RE: A00972129 262 BOWHILL ROAD, WILLAWONG – RESPONSE TO INFORMATION REQUEST

Application Details	
Applicant	Murphy Urquhart Investments Pty Ltd c/o- The Development Directive Pty Ltd
Application Number	A006972129
Application Address	262 Bowhill Road, Willawong
Property Description	Part of Lot 1 on SP237974

Figure 1: Alternative indicative location for stormwater outlet (Attachment 3 – Annexure A).

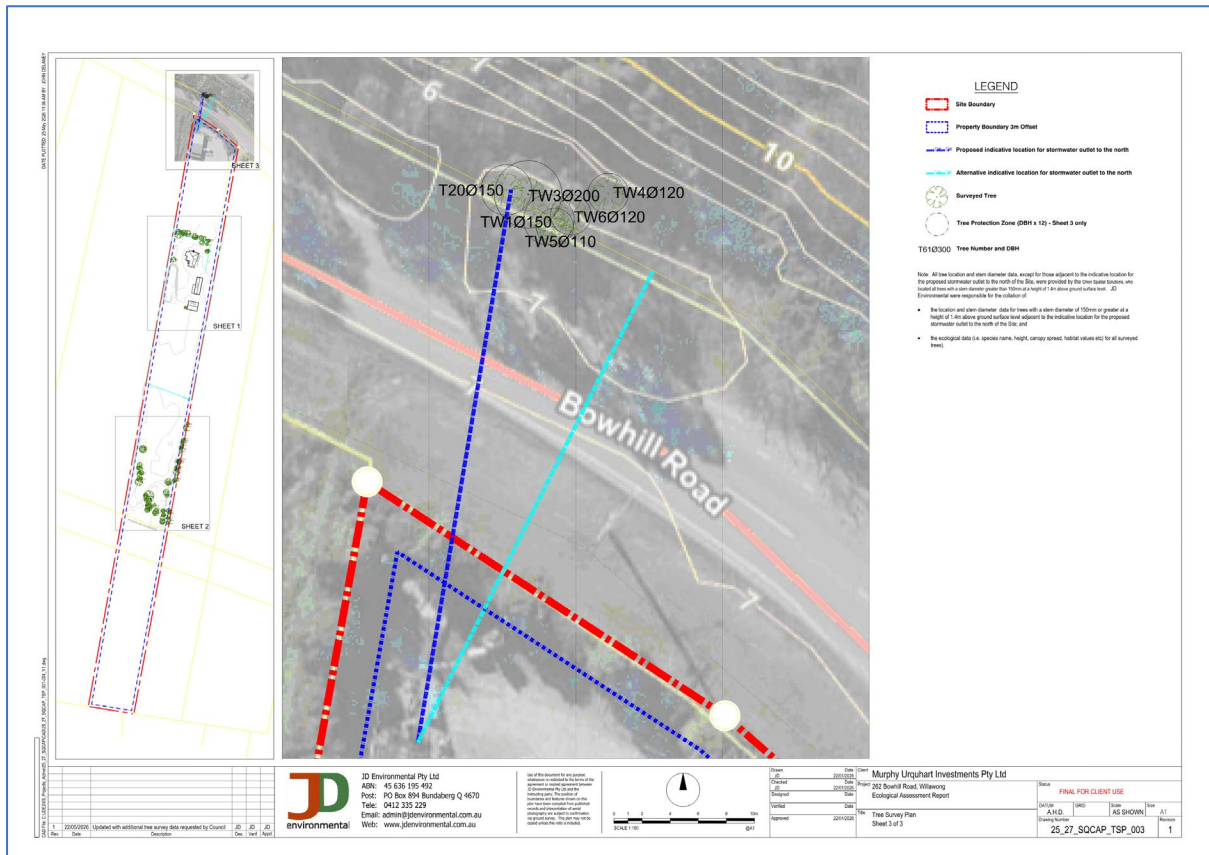
4. *The proposed stormwater plans stormwater plans 'Concept Finished Surface Levels and Stormwater Drainage Plan' (drawing no. 25-1095-DA200 Issue B') identifies an 'outlet to existing open channel' located on the Cleanaway Resource Recycling site (343 Bowhill Road, Willawong). The site is mapped under the Biodiversity area overlay and the Waterway corridors overlay and is vegetated. It is unclear if there are any impacts to ecological values located on the site.*

- a. *Where works are located with the mapped Biodiversity areas overlay or Waterway corridors overlay provide an updated Vegetation Retention Plan that includes:*

JDE has proposed that potential impacts to the identified native trees could be avoided if the location was shifted to an open area ~10 metres to the east of the currently proposed location, the only vegetation that would be impacted is a thicket of *Leucaena* (a non-native environmental weed) and would still remain outside of Biodiversity area and Waterway Corridors overlays. See amended location of outlet as described in Figure 1 and within Annexure A of Attachment 2.

The proposed amendment to the stormwater outlet location within 343 Bowhill Road, Willawong ensures that the proposed outlet is not within Biodiversity/Waterway overlays and the City Plan and would avoid impacts on identified native vegetation within the site.
